Kenavon Drive, Reading

Consented and Proposed Comparison
East Block Stage 4 Amendments, June 2021

8.11 Consented and Proposed Comparison Elevations

8.11 Consented and Proposed Comparison Elevations

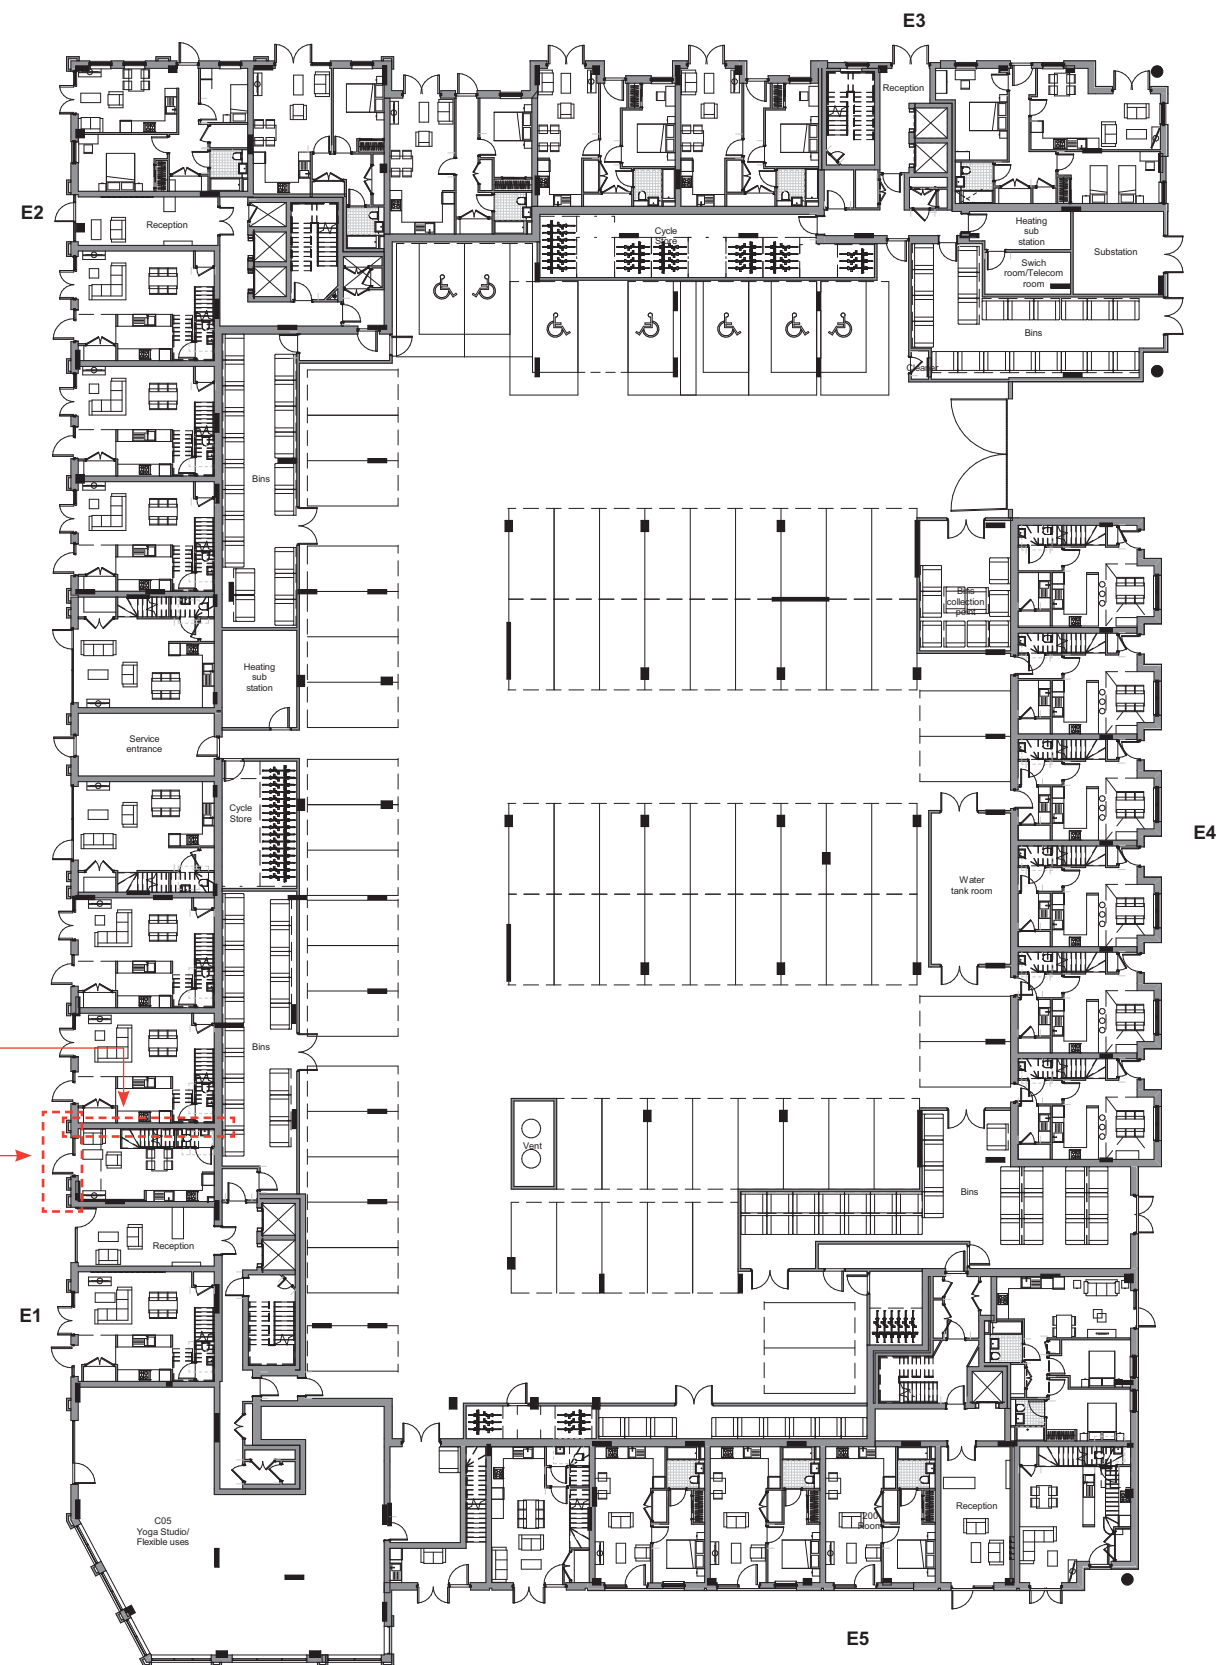
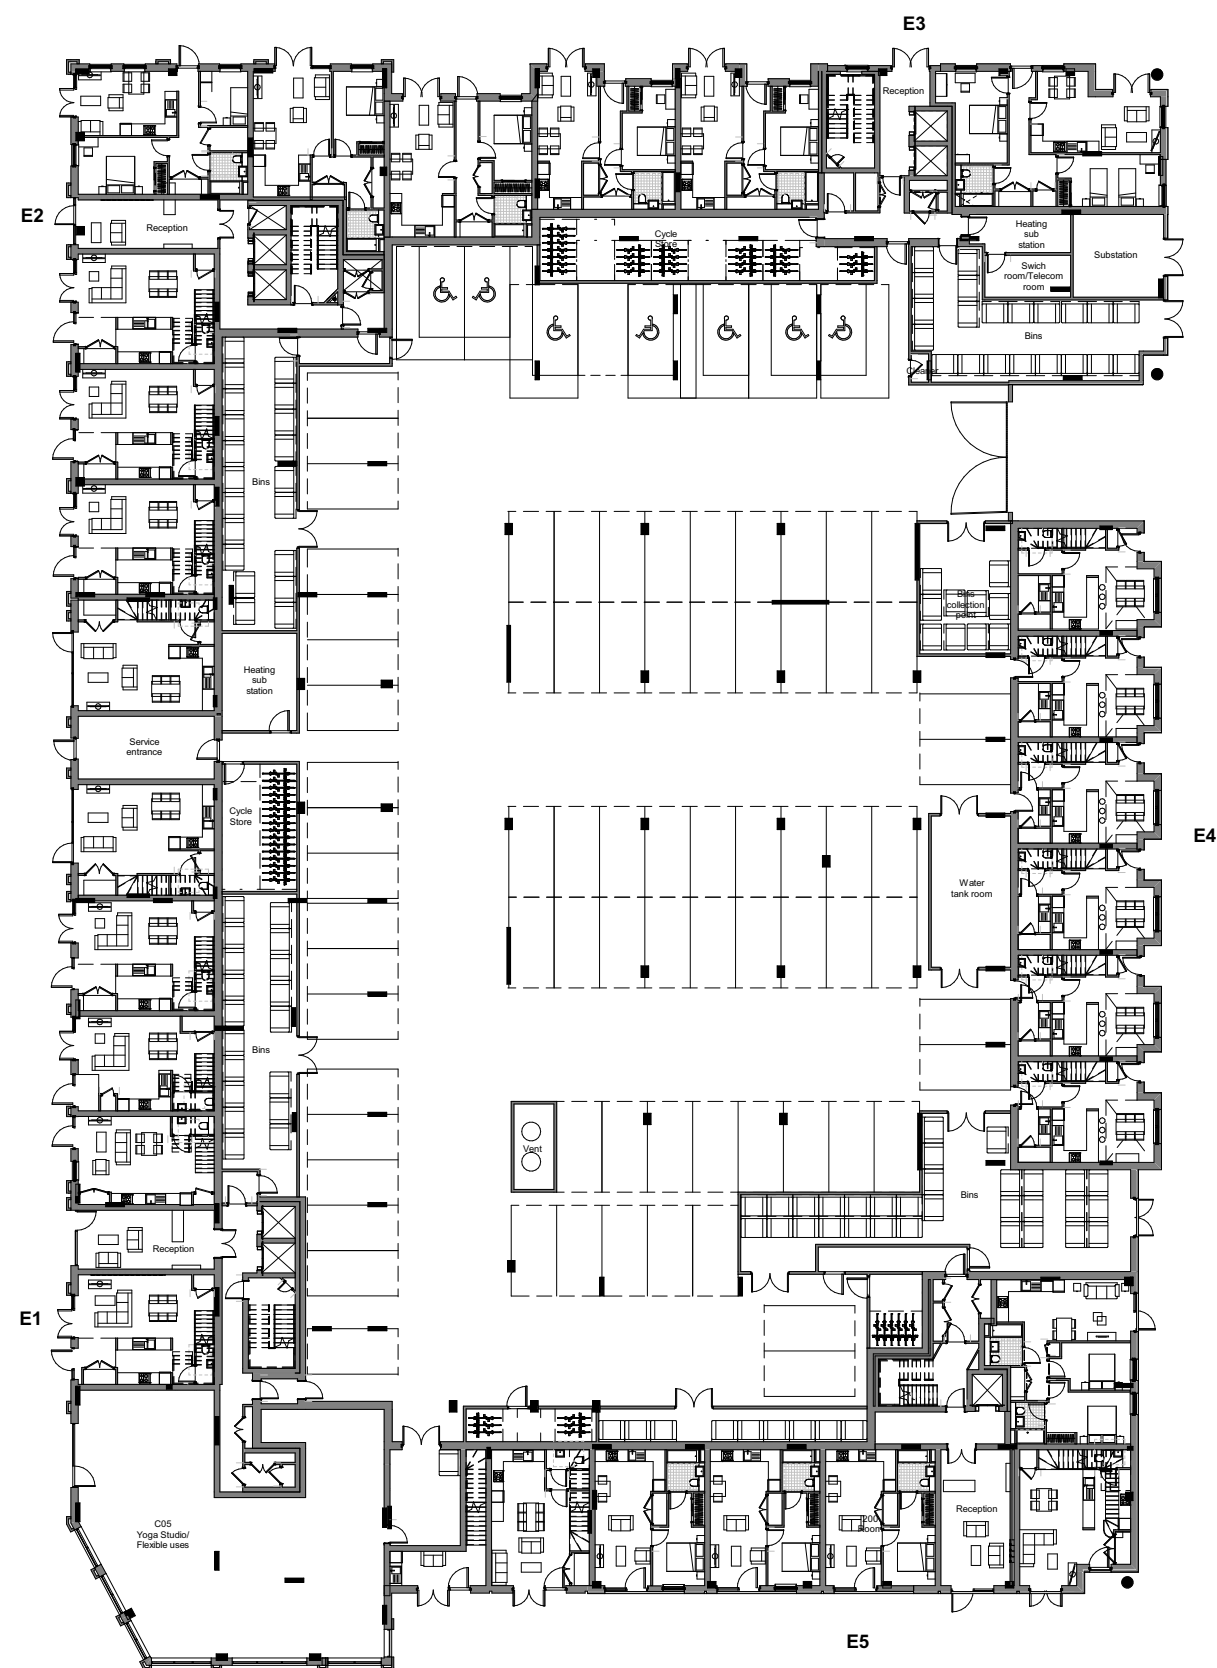
Party Wall between 1 Bed and
2 Bed Duplexes Amended

Window Arrangement to
1B Duplex Amended

- Enlarging 1 Bed Duplex in Core E1
- Adding a Bay of Windows to Increase Daylight into Habitable Rooms in 1 Bed Duplex

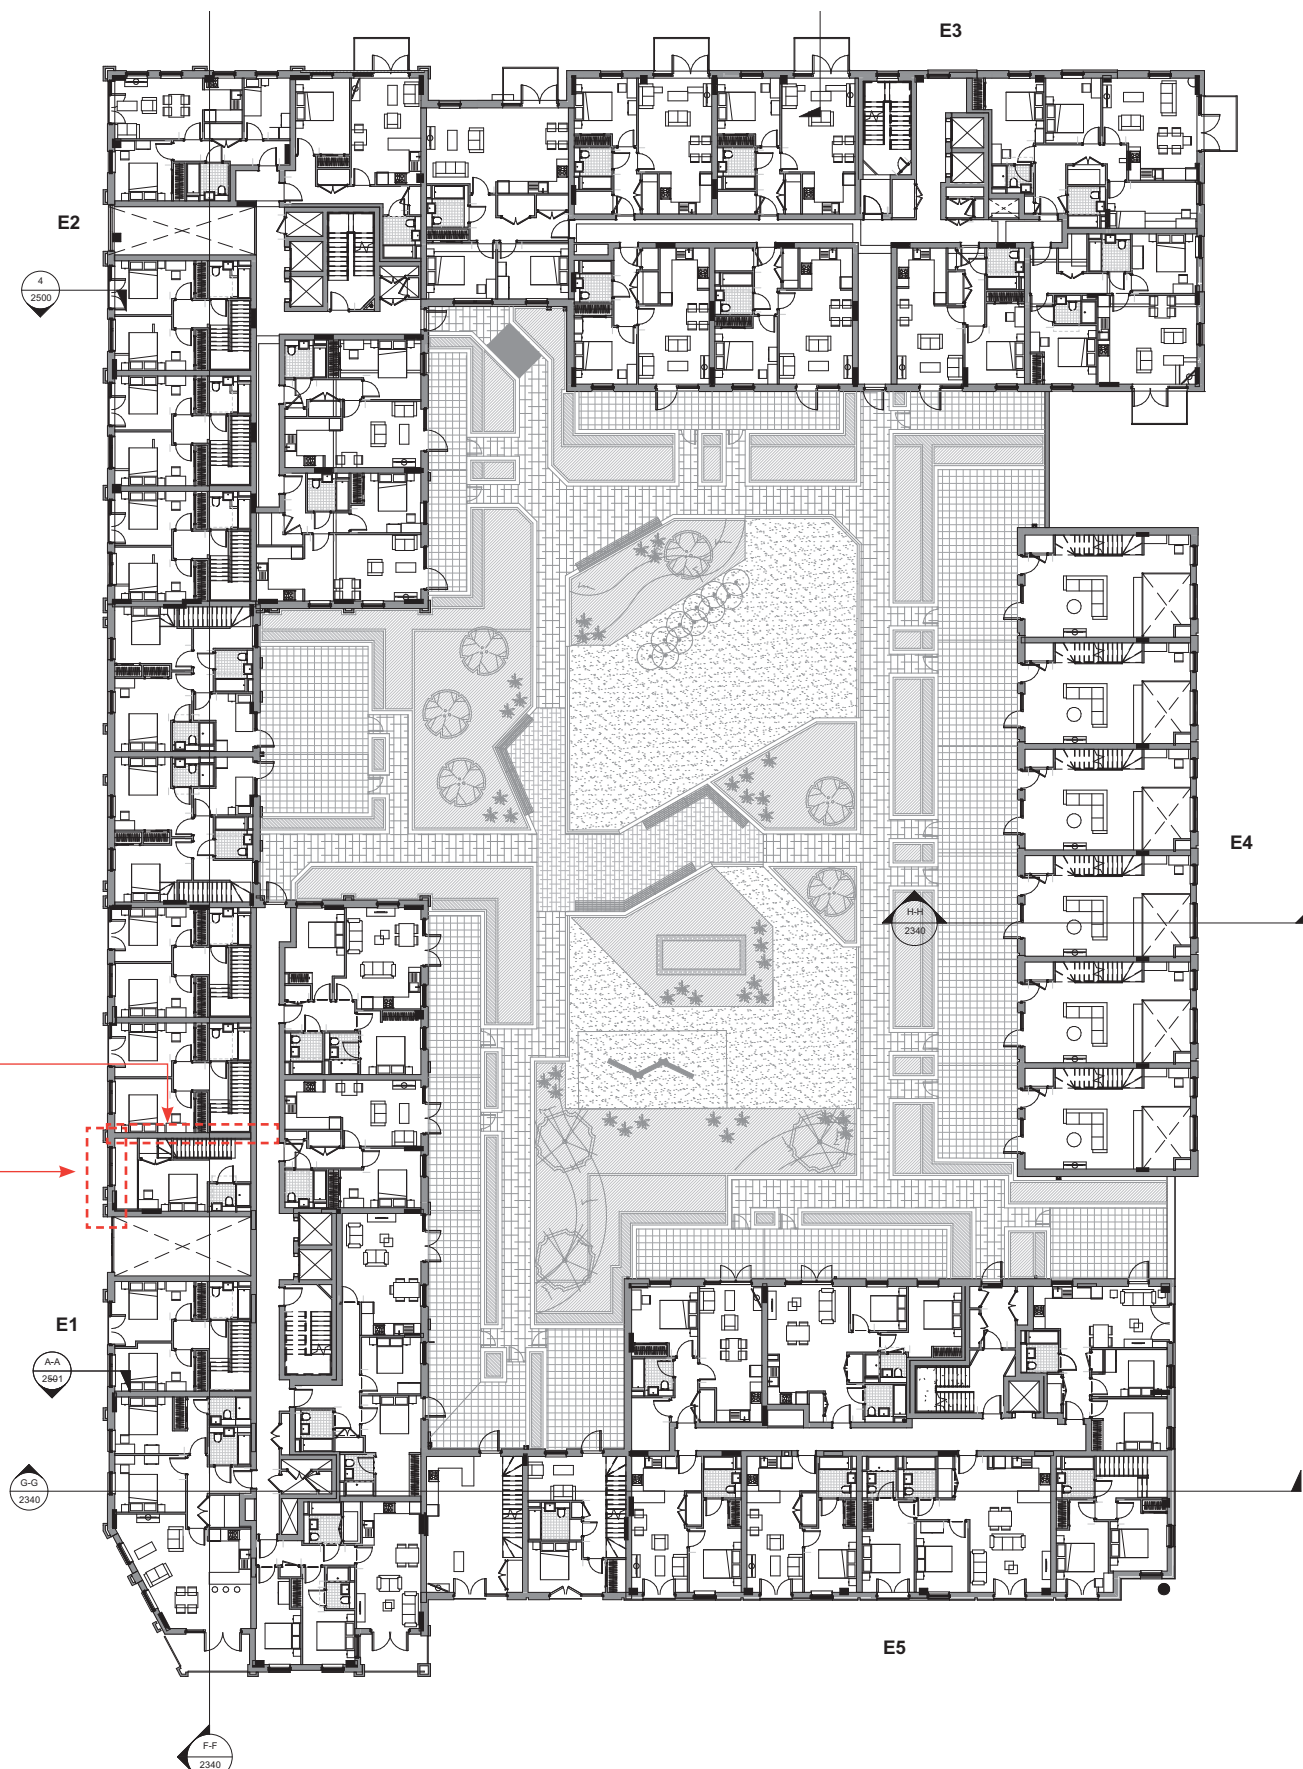
Party Wall between 1 Bed and
2 Bed Duplexes Amended

Window Arrangement to
1B Duplex Amended

- Enlarging 1 Bed Duplex in Core E1
- Adding a Bay of Windows to Increase Daylight into Habitable Rooms in 1 Bed Duplex
